CITY OF PALM SPRINGS

MEMORANDUM

Subject: ELEMENTAL ARCHITECTURE FOR REVISIONS TO A MINOR ARCHITECTURAL APPLICATION FOR EXTERIOR MODIFICATIONS TO AN EXSTING COMMERCIAL BUILDING LOCATED AT 2481 NORTH PALM CANYON DRIVE, ZONE C-1 (CASE 3.4320 MAA) (RB)

Architectural Review Response Letter

1 GROUND FLOOR
SCALE: 1/4"=1'-0"

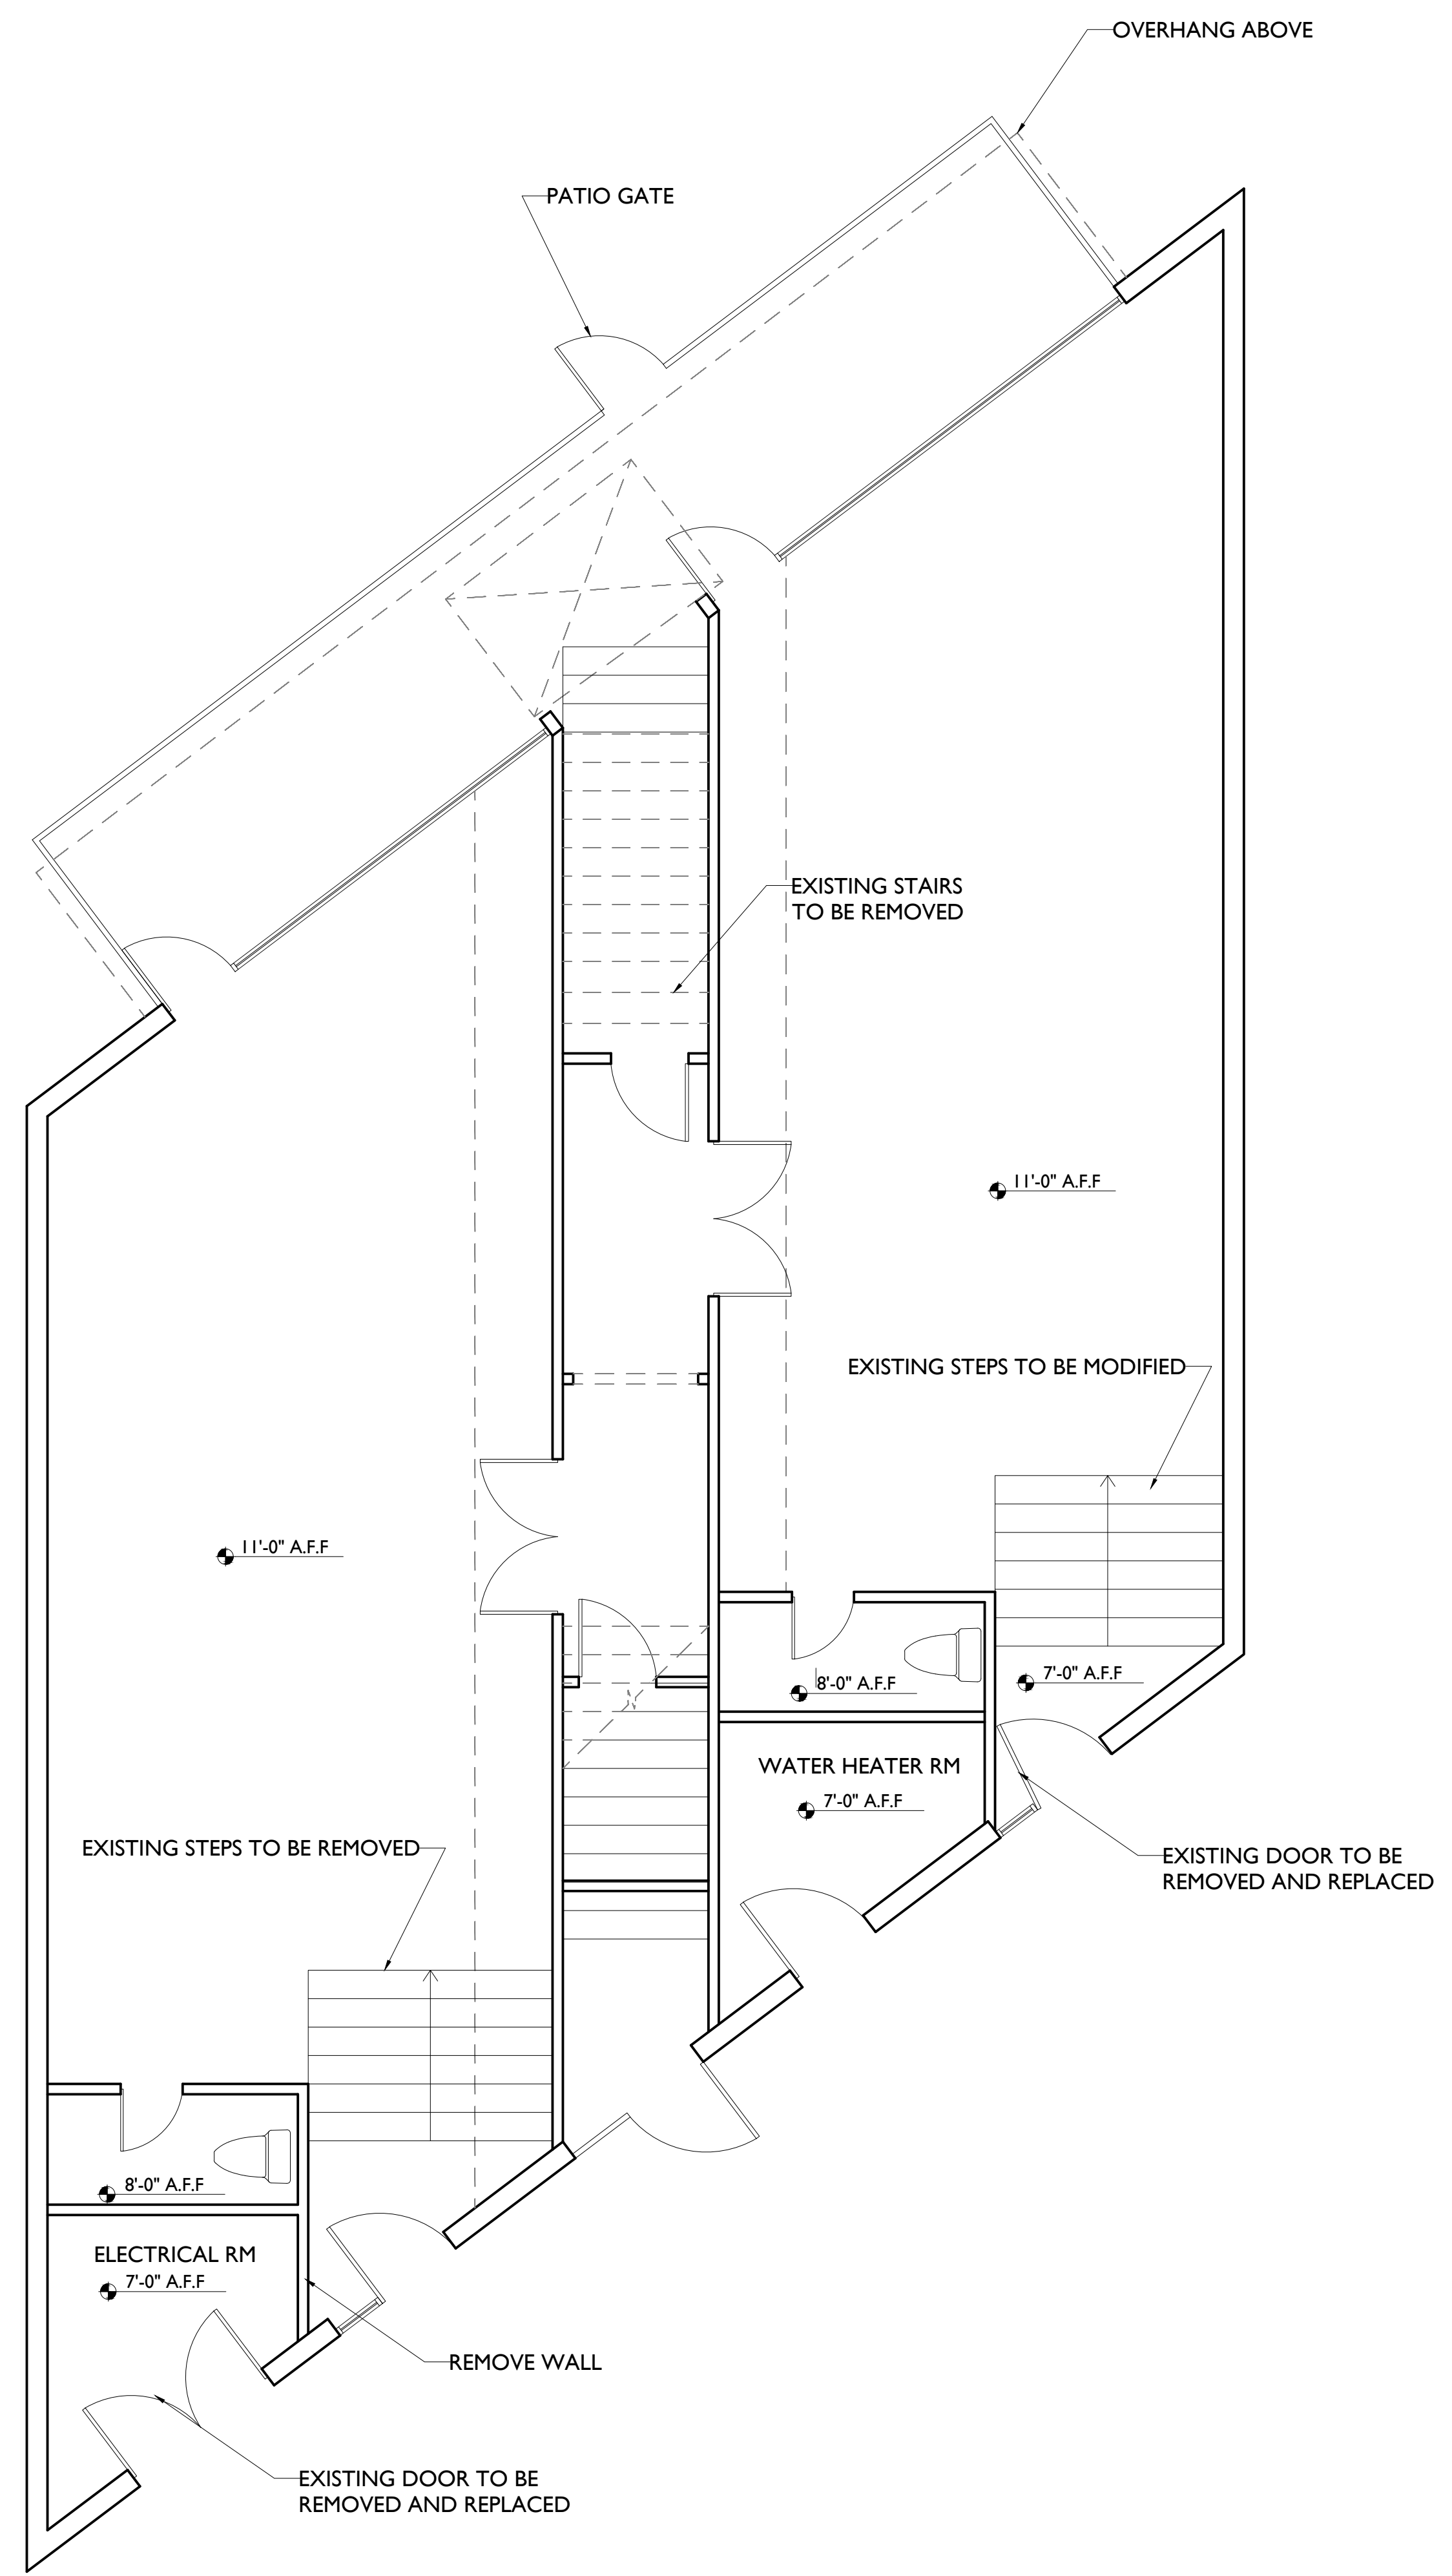
1. ADA/ Handicap Ramp.

Please find ada parking stall added to the parking lot. In addition, please see north ada entrance and ada lift. The building cannot accommodate a ramp therefore an ada lift was proposed

2 2ND LEVEL
SCALE: 1/4"=1'-0"

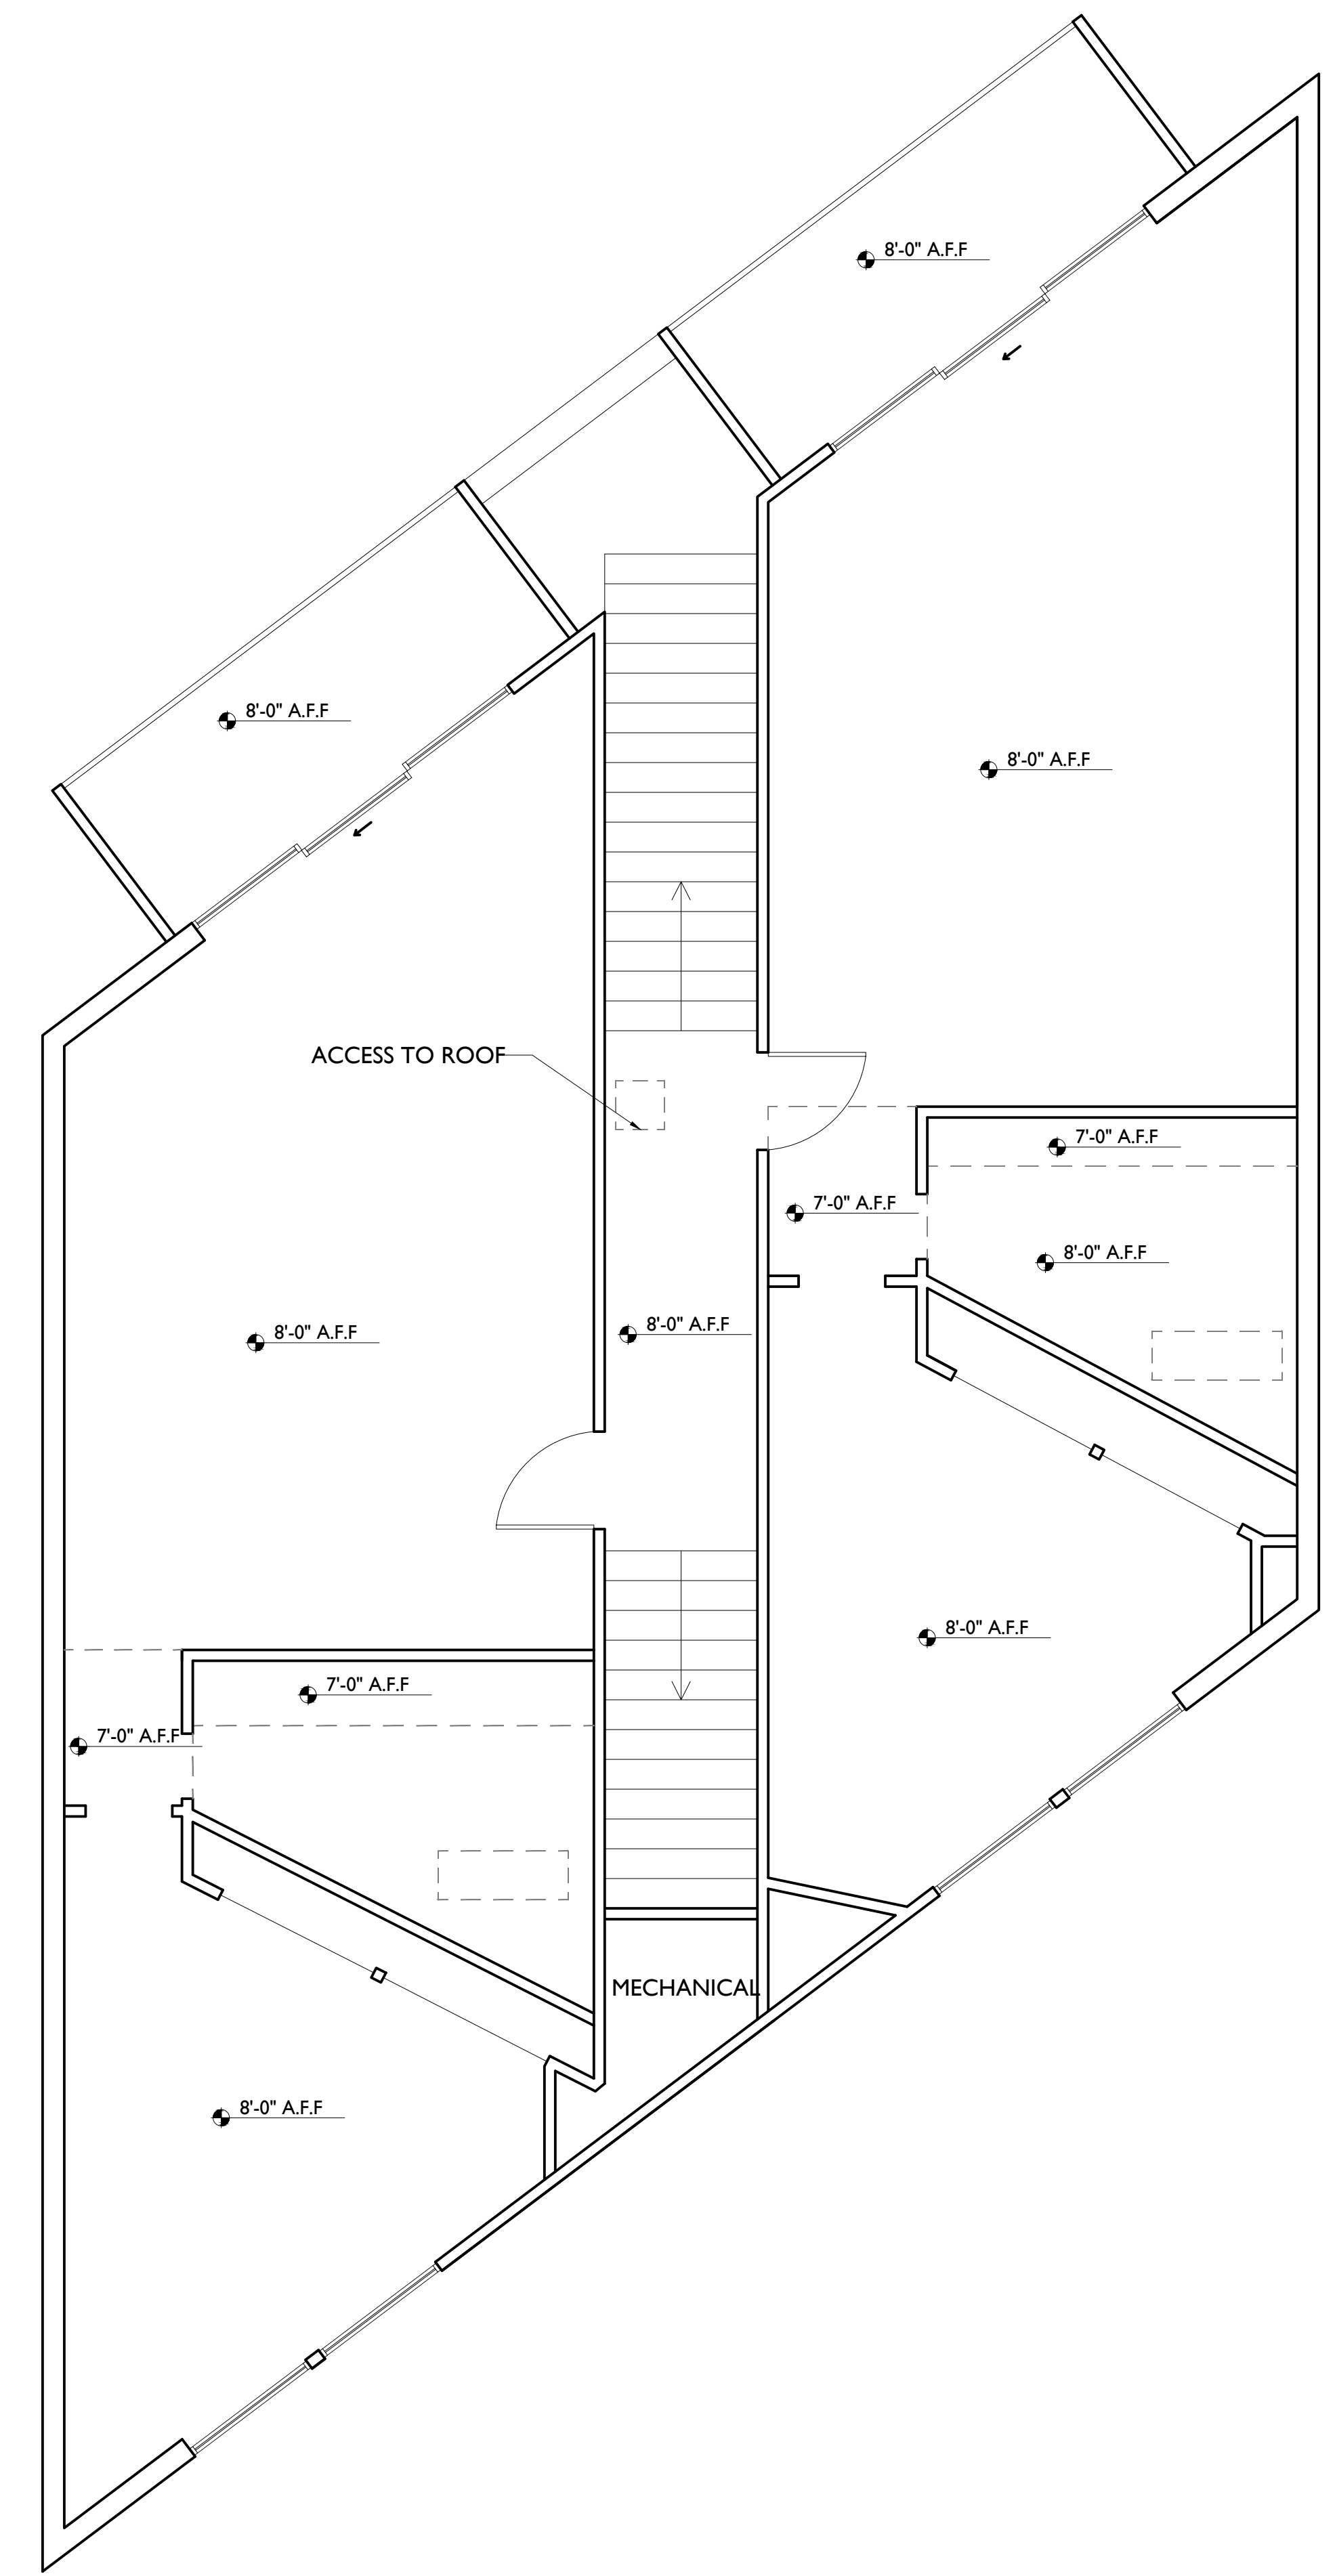
8. Showing a height of 2'7" railing it should be 3'.

The parapet wall sits higher than the roof therefore. That was giving me the extra height needed. However, due to the pedestal system new elevations were provided which shows a complying 42" guardrail.

1 SECTION AT CANOPY
SCALE: 1"=1'-0"

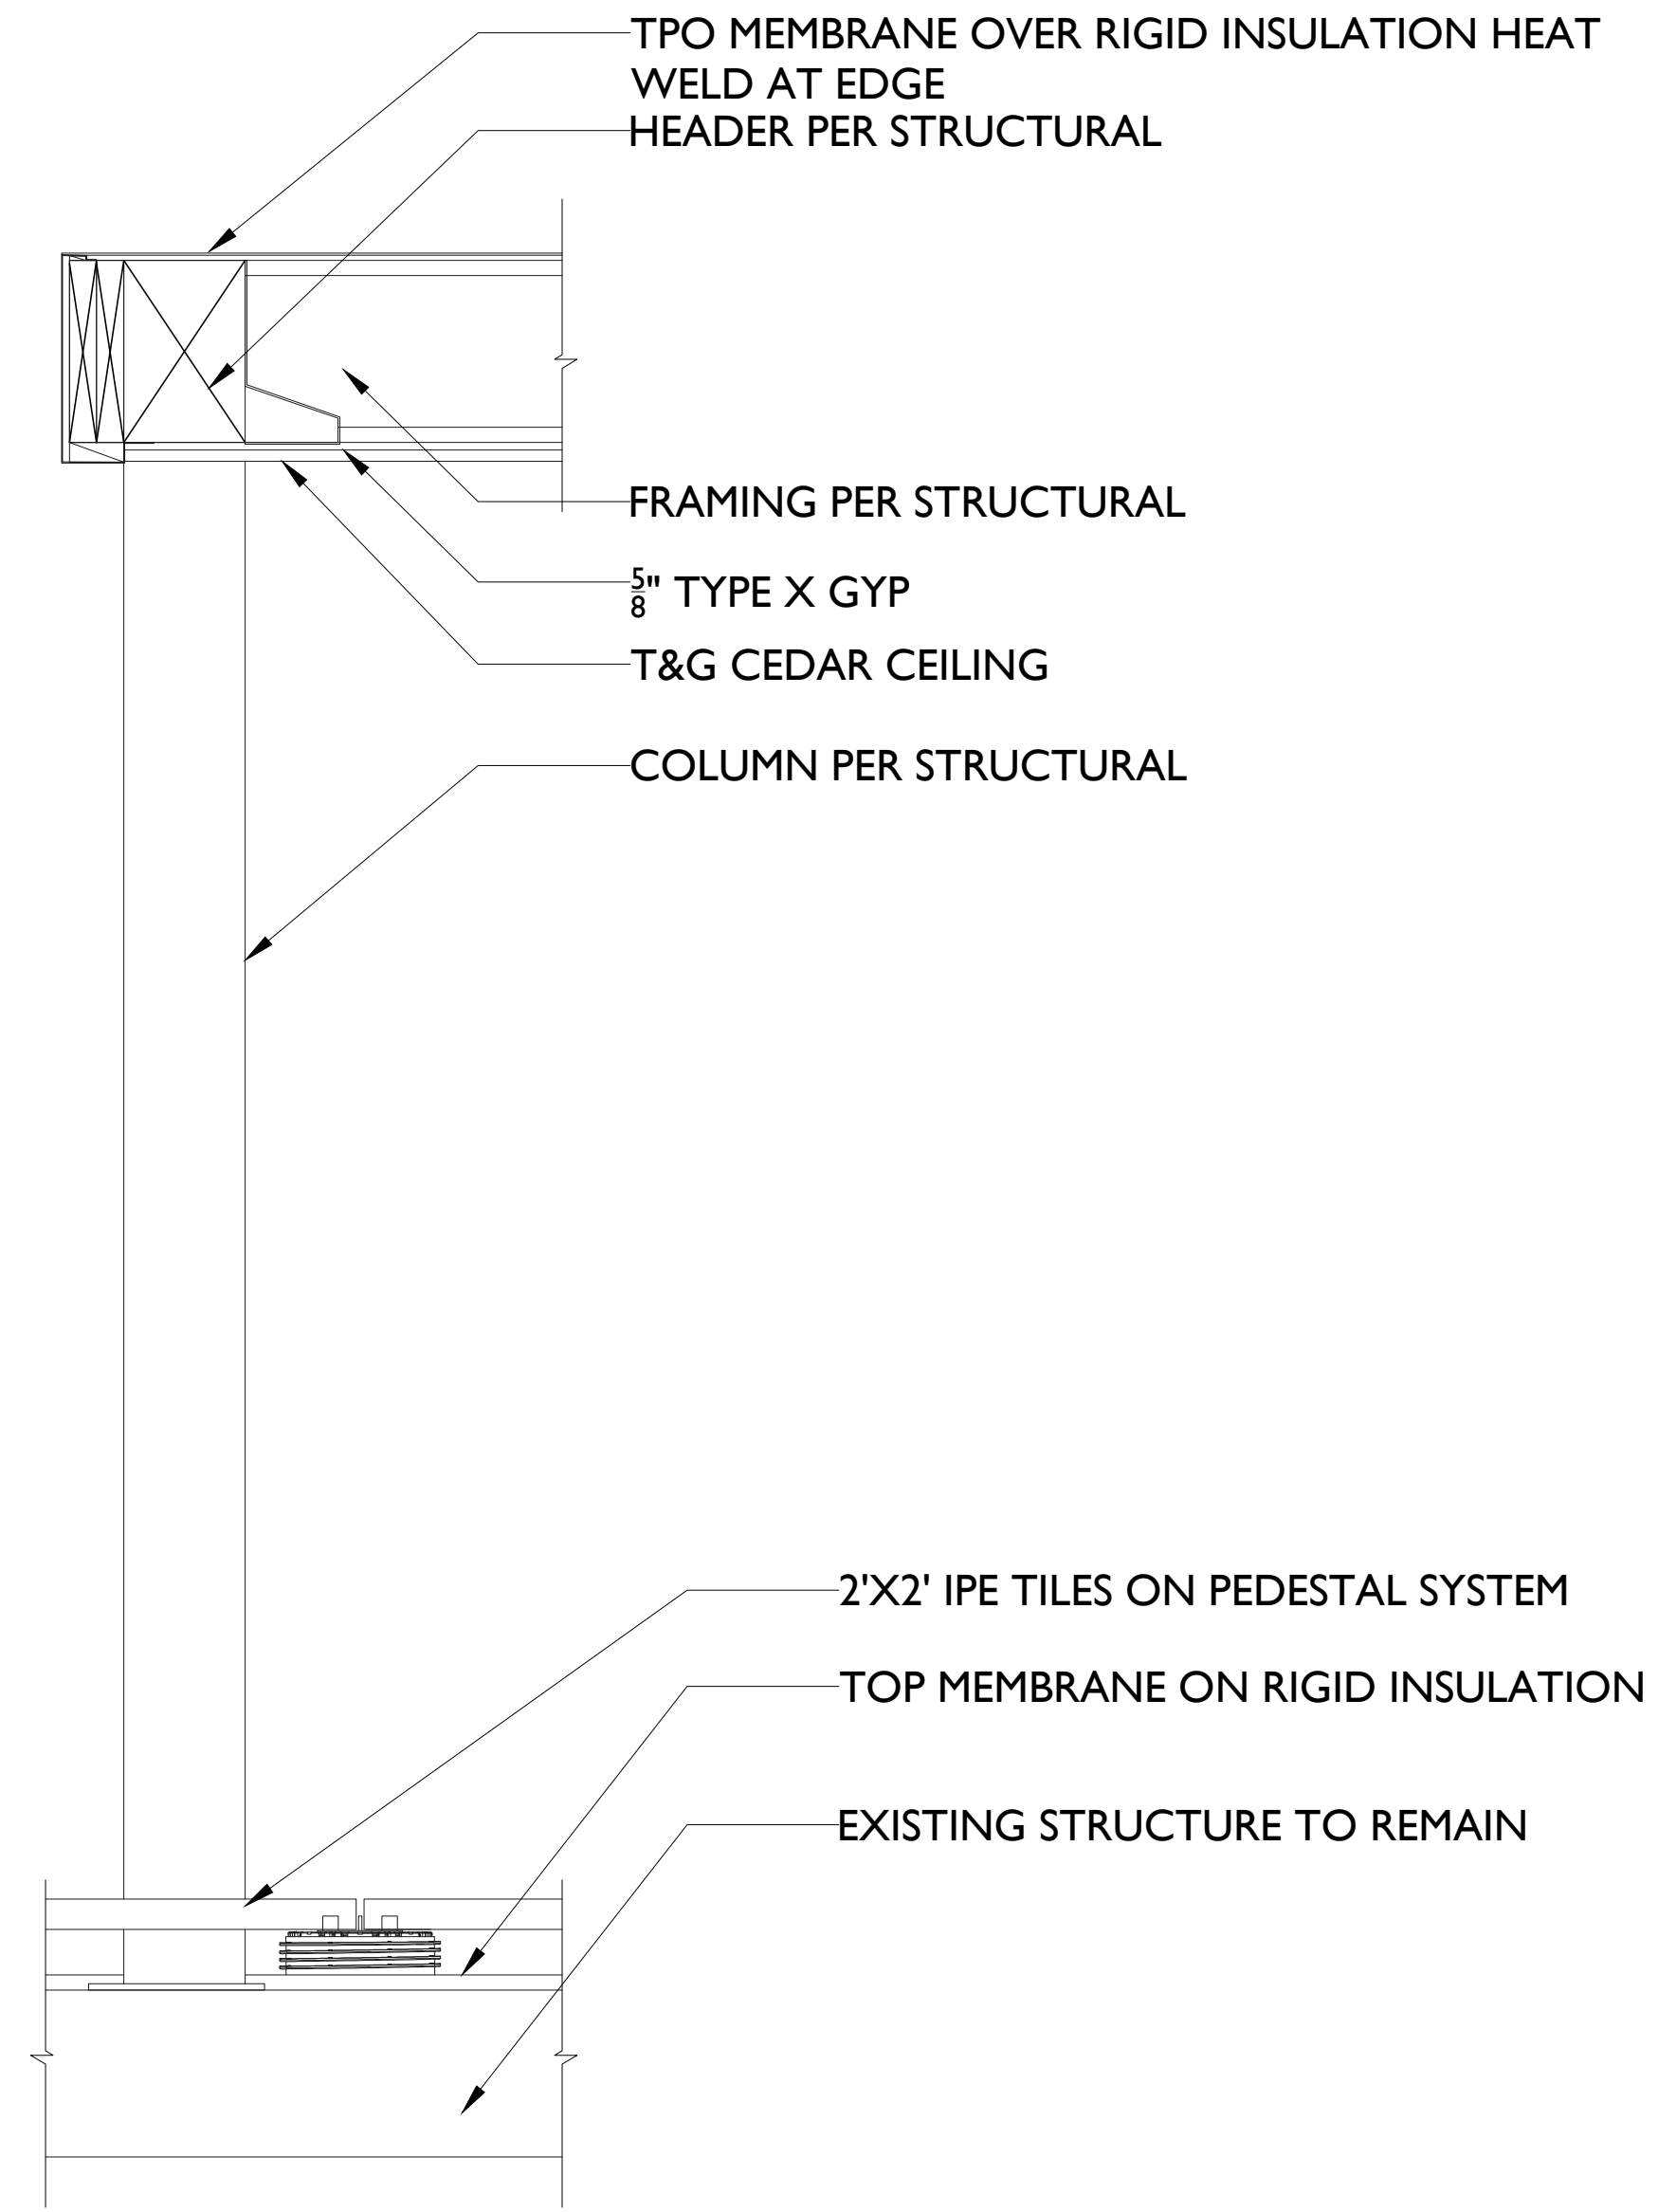
4. Show the posts holding awning.

5. Make awning more obvious as how it is supported.

Please find posts shown on the roofplan.

The awning will be supported by 3 posts and the back will be supported by the stair enclosure structure. Refer to roof plan and elevations. Also please see schematic canopy section on sheet A1.5.
